TB 189

## TECHNICAL BULLETIN

**Product :** Stannah Midilift SL & GL (hydraulic platform lifts) manufactured after July 2019

**Subject :** Pit prop inspection/replacement before entering pit

### Measurements:

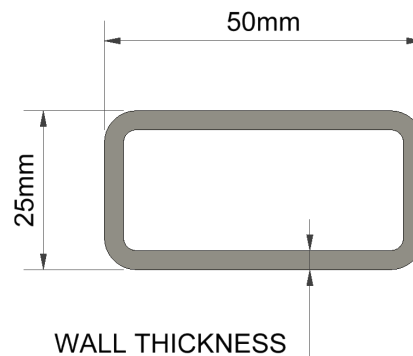
The thickness of the tube should be measured at the tube end. It should be possible to determine if the tube has a wall thickness of 2mm or 3mm by use of a tape measure/rule with 1mm incremental marks.

There may be a seam on the internal faces of the tube, ensure the measurement is taken at least 6mm away from any seam. There may also be a localised build-up of paint at some points on the end of the tube; measurements should be taken at points where paint is at its thinnest coating.

**Any tube that is found to be less than 3mm thick must be removed then disposed of and replaced with a 3mm thick tube.**

If there is any doubt over the wall thickness measurement, always replace with a 3mm tube.

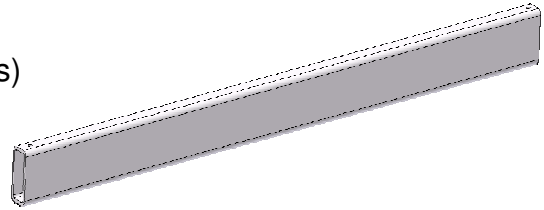
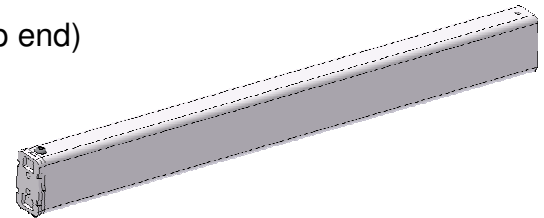
The parts supplied are either:

- Indoor models 6103835 (open both ends)

- Outdoor models 6103838 (capped at top end)

Please ensure that capped versions are used on outdoor models as these variants have a protective undercoat, as well as the cap, to offer better corrosion resistance.
